From: Howard Tong <[REDACTED]>
Sent: 03 February 2026 18:05
To: tpbpd/PLAND
Cc: [REDACTED]
Subject: s.16 Planning Application No. A/YL-KTS/1079 - Reply to Departmental Comment (FSD/DSD)
Attachments: Attachment 1 - Fire Services Proposal.pdf; Attachment 2 - Drainage Proposal.pdf; Attachment 3 - Colour Water Test Report on Existing Village Box Culvert.pdf; Attachment 4 - Table for the Hydraulic Design for Pipe, Sewers and Channel, A18.pdf; Attachment 5 - Letter from the Adjoining Owner of Lot TS 601.pdf
Categories: Internet Email

Refer to captioned Planning Application No. A/YL-KTS/1079, please find below our reply to departmental comments (FSD/DSD) for TPB consideration:

TRAINING CENTRE
 LOTS NO. 602 S.B.(Part), 602 S.C.(Part), 602 R.P., 603 S.C.(Part), 603 S.D.(Part), 603 R.P., IN D.D. 106, KAM SHING ROAD, KAM TIN, YUEN LONG.

G/F DRAINAGE PLAN (UNDERGROUND)

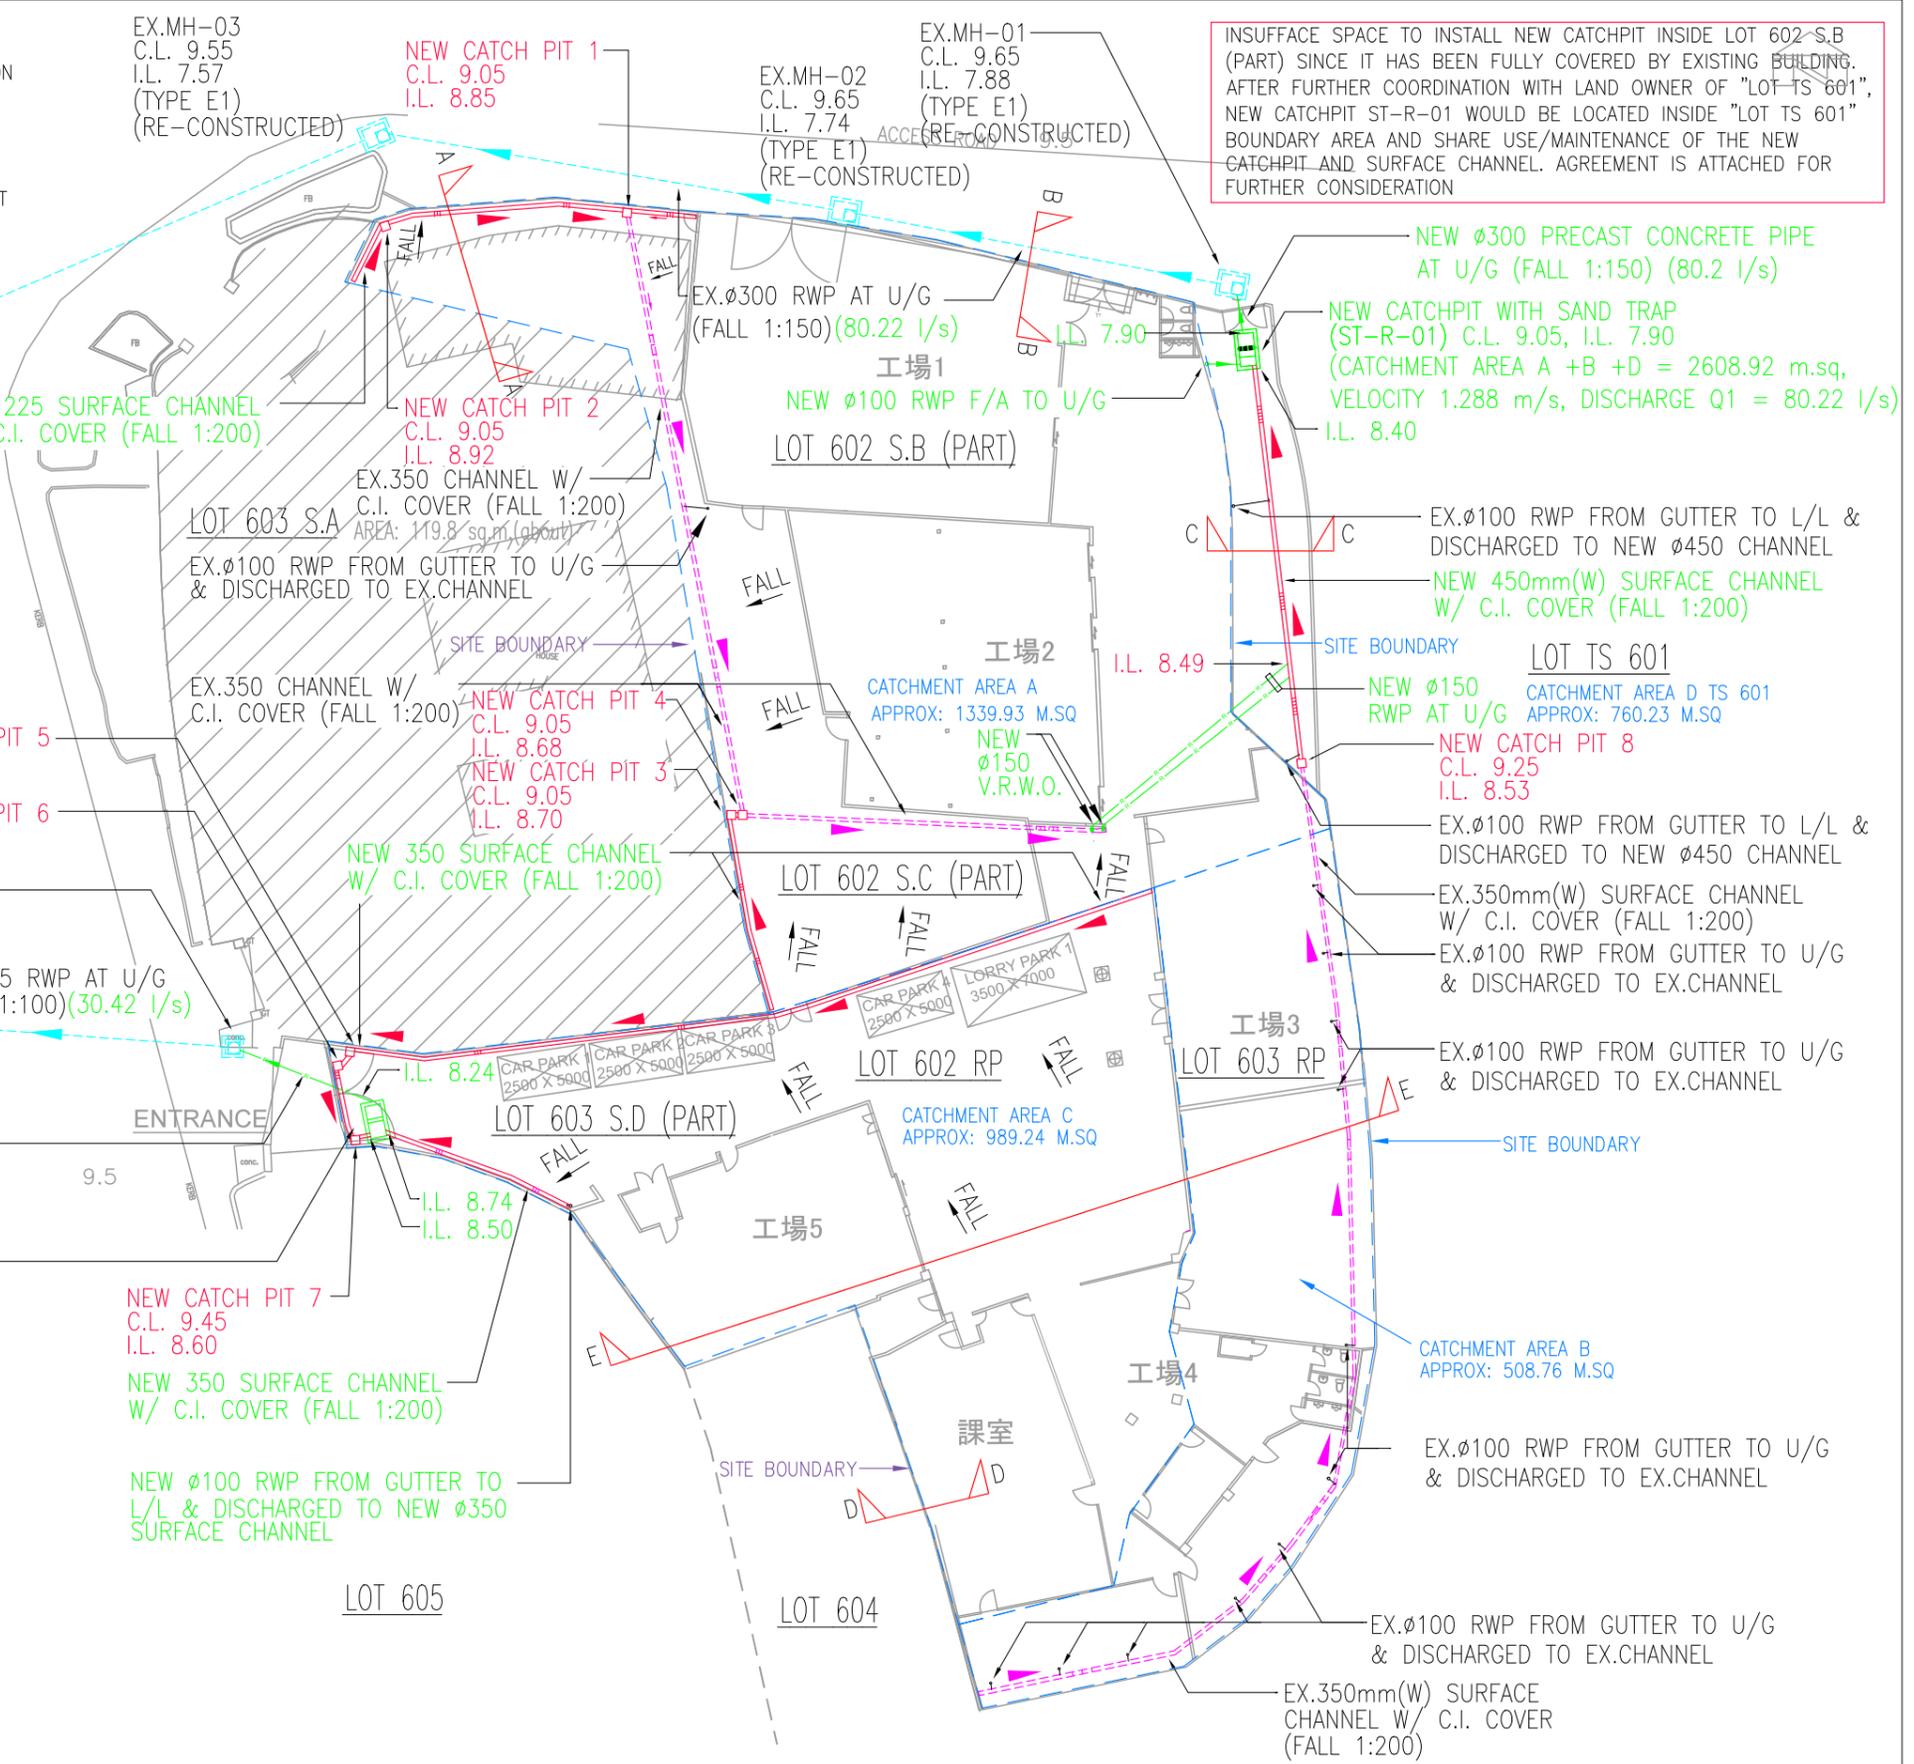
5. Insufficient space to install new catchpit inside Lot 602 S.B. (Part) since it has been fully covered by existing building. After further coordination with Land Owner of "Lot TS 601", new catchpit ST-R-01 would be located inside "Lot TS 601" boundary area and share the use / maintenance of the new catchpit and surface channel. Agreement is attached for further consideration.

INSUFFICIENT SPACE TO INSTALL NEW CATCHPIT INSIDE LOT 602-S.B (PART) SINCE IT HAS BEEN FULLY COVERED BY EXISTING BUILDING. AFTER FURTHER COORDINATION WITH LAND OWNER OF "LOT TS 601", NEW CATCHPIT ST-R-01 WOULD BE LOCATED INSIDE "LOT TS 601" BOUNDARY AREA AND SHARE USE/MAINTENANCE OF THE NEW CATCHPIT AND SURFACE CHANNEL. AGREEMENT IS ATTACHED FOR FURTHER CONSIDERATION

THE RUNOFF FROM THE DEVELOPMENT SITE IS PROPOSED TO BE DISCHARGED TO AN EXISTING MANHOLE VIA NEW SAND TRAP (ST-R-01) BY A NEW DIA. 300mm DRAINAGE PIPE.

AS A RESULT, DIA. 300 PRECAST CONCRETE DRAINAGE PIPE (ks=0.6mm) RUN AT GRADIENT OF 1:150@ VELOCITY 1.288 m/s, CAN ACCOMMODATE 81.9369 l/s, WHICH IS GREATER THAN THE STORMWATER RUNOFF AT 80.22 l/s FROM THE DEVELOPMENT SITE.

FROM ABOVE, IT CAN CONCLUDE THAT THE PROPSOED DIA 300mm DRAINAGE PIPE IS ADEQUATE FOR COLLECTING THE STORMWATER FROM THE DEVELOPMENT SITE.

G/F DRAINAGE PLAN (HIGH LEVEL & ABOVEGROUND)
SCALE 1:200@A1, 1:400@A3

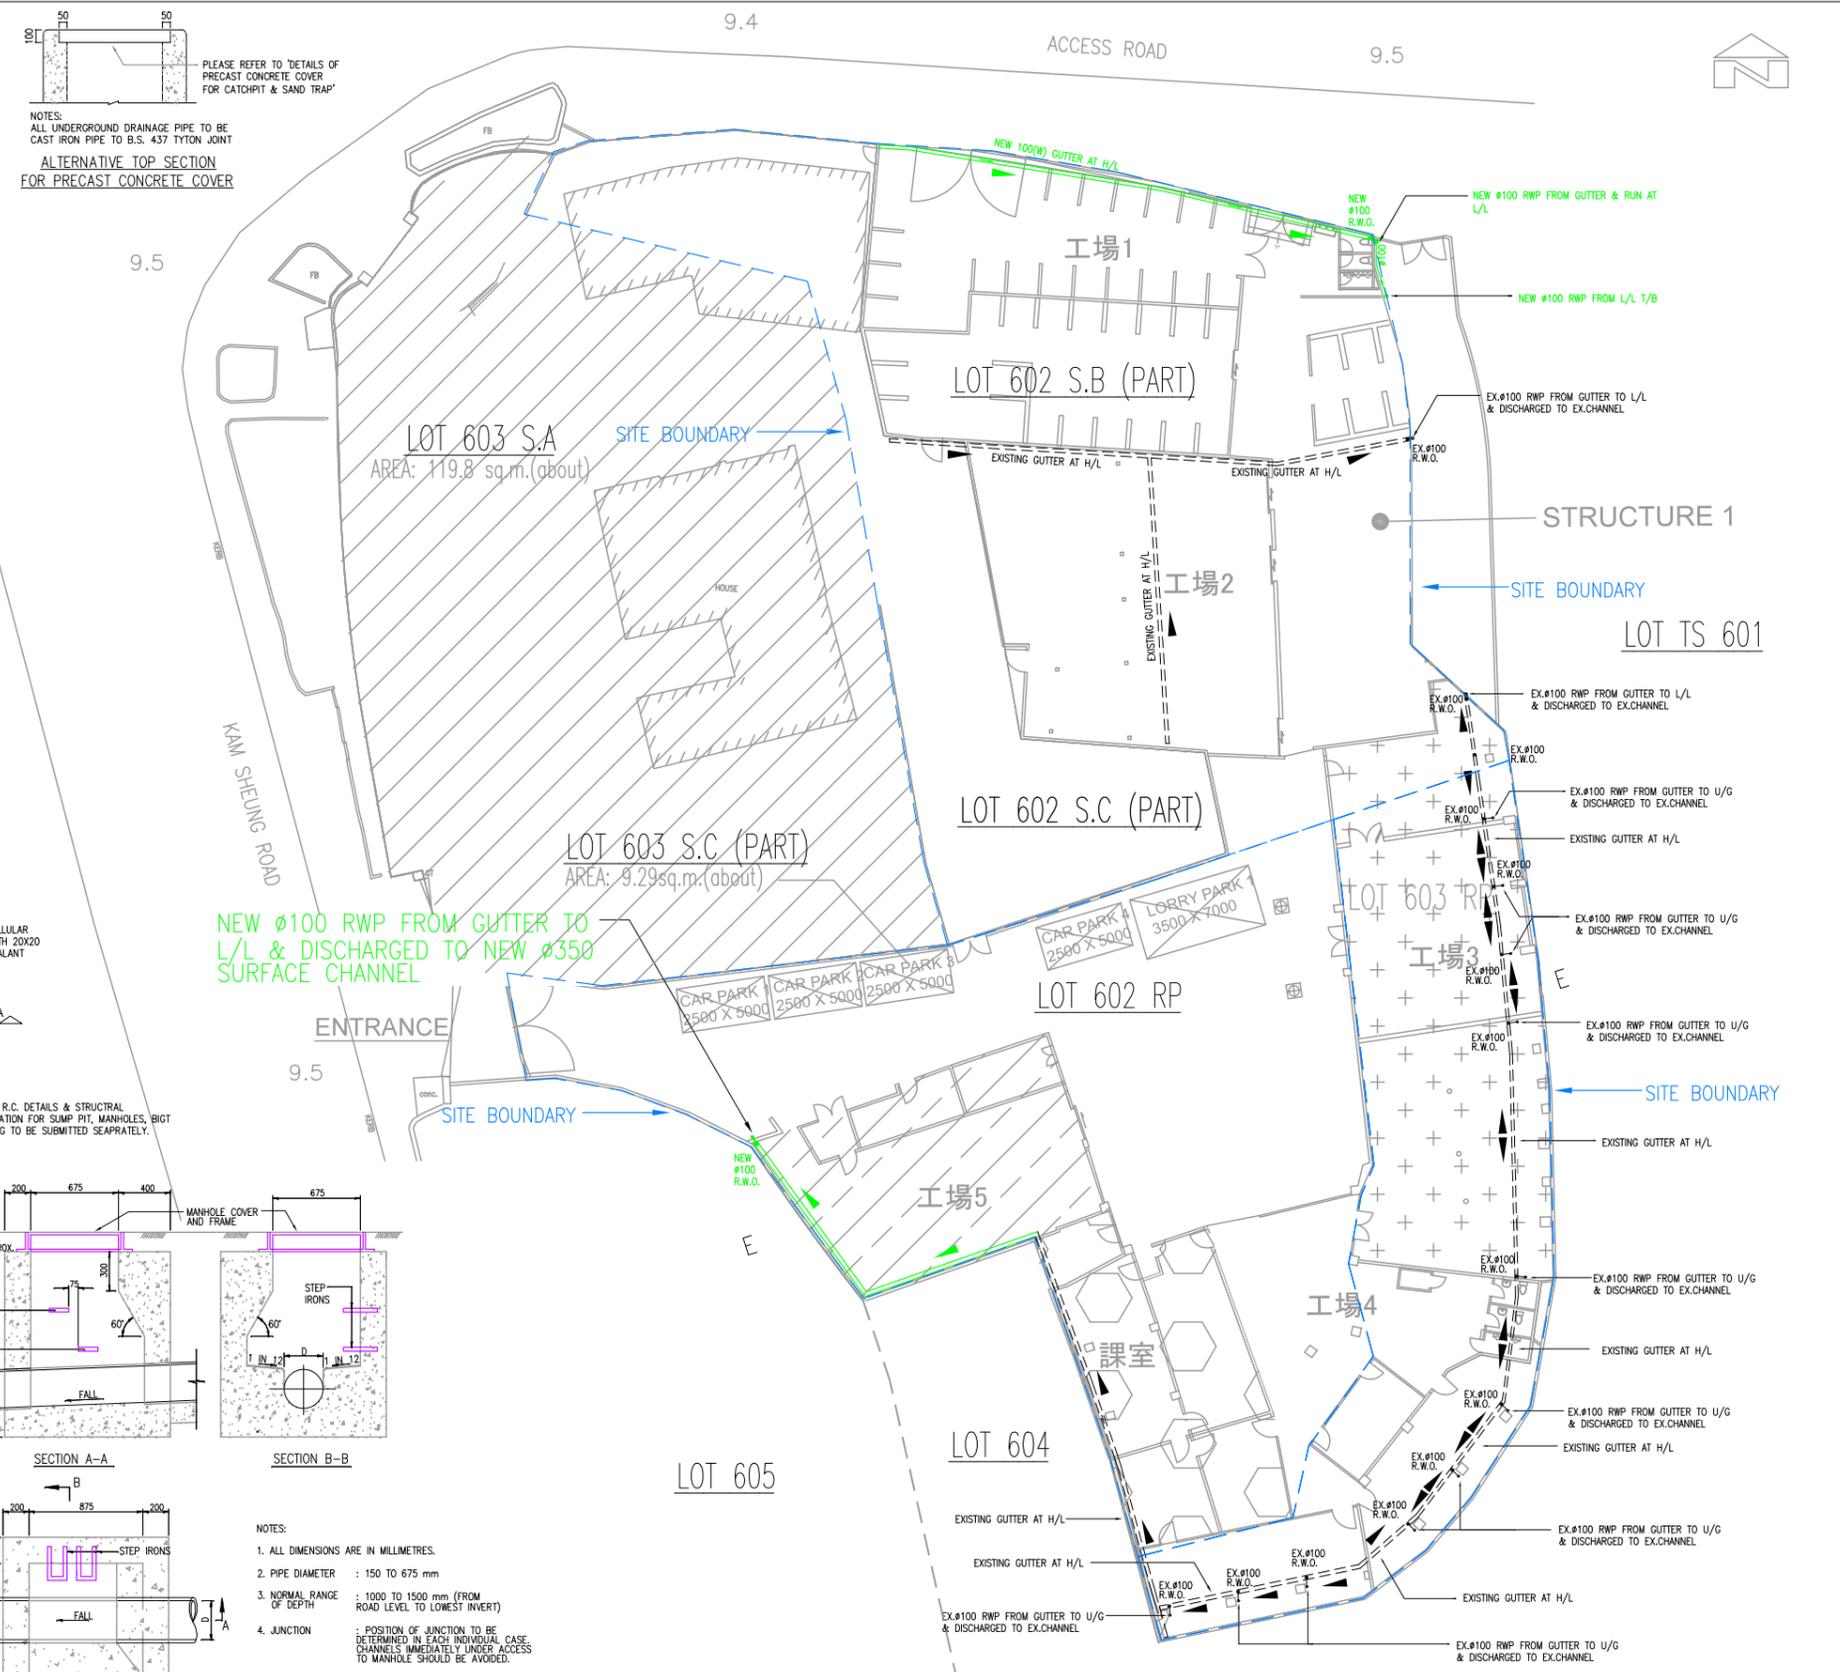
Please find attached Drainage Proposal - Item a) to d) to incorporate DSD comment:

EXISTING DRAINAGE PLAN (UNDERGROUND)
SCALE 1:200@A1, 1:400@A3

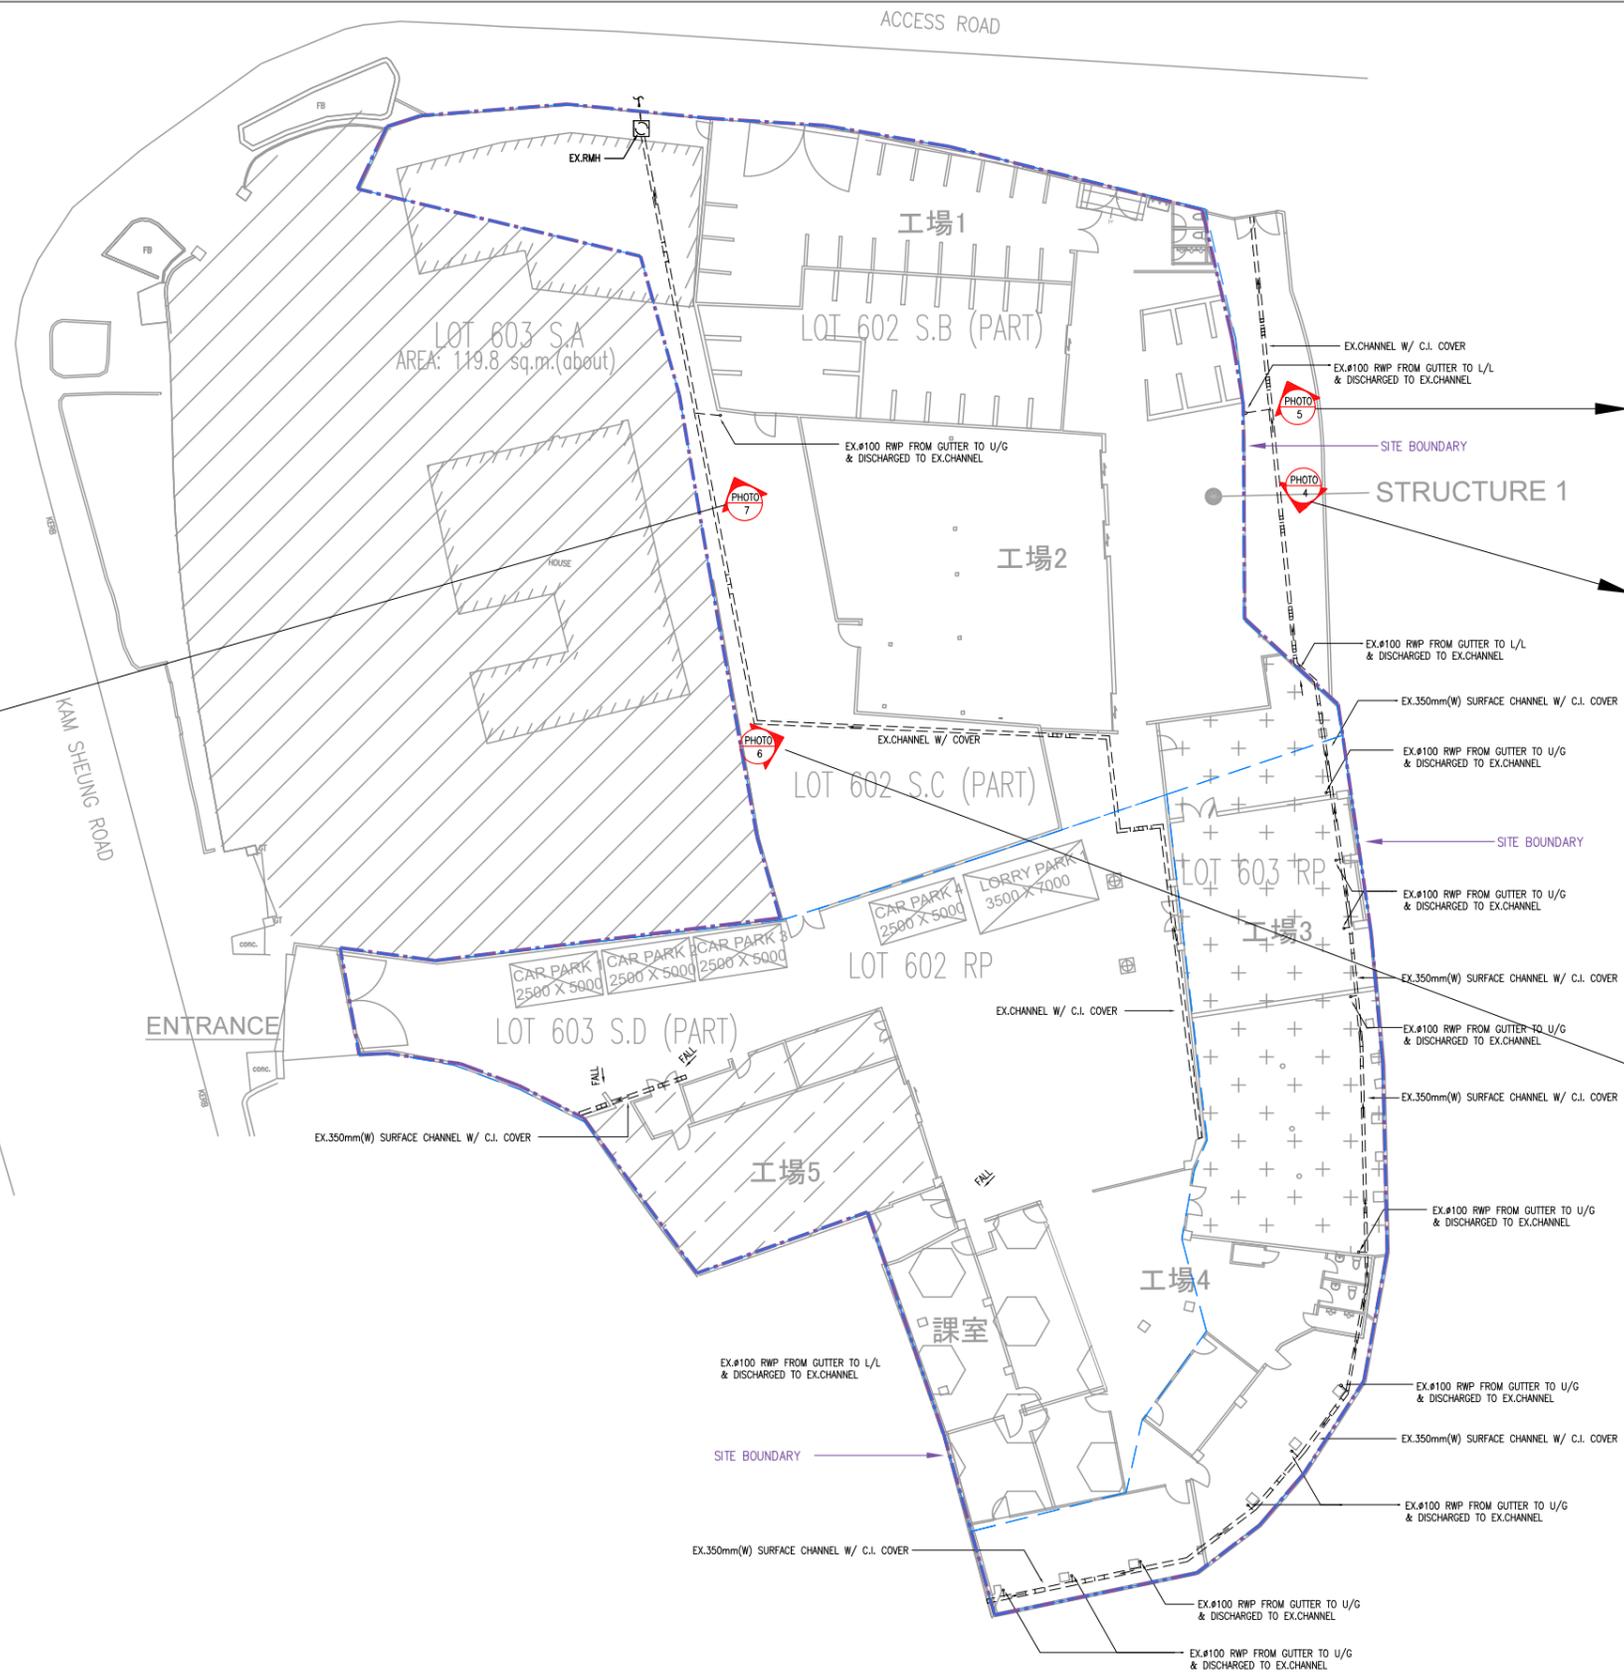
3. All drainage pipe and manhole inside and outside lot boundary showing on this drawing to be maintenance by this Applicant.
4. Site survey for existing underground drainage installation will be carried out after award of works, contractor to verify the actual size of existing culvert and pipework, upgrading works would be carried out if necessary.
